## Service Information no. 205

### New improved compressor for Typhoon!

### **Compressor Typhoon 50 Hz Item No. 0604151 EBS 10020219**

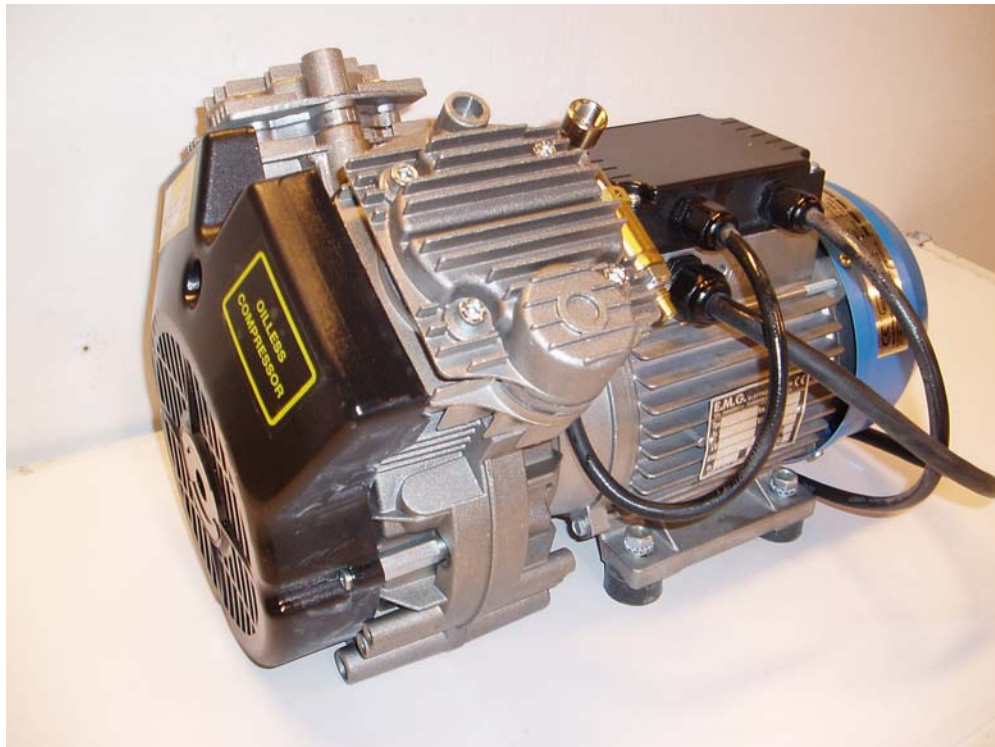
**We have now changed the compressor for the Typhoon to a type H motor, which can run for a longer period of time during foaming.**

This compressor is more resistant than the previous compressor type. Together with the manufacturer, we have developed a motor type that is able to run continuously in the typhoon cabinet without cutting off on the internal motor protection. This means that the customer now can foam for a longer period of time than previously. We expect more than one hour of foaming ability.
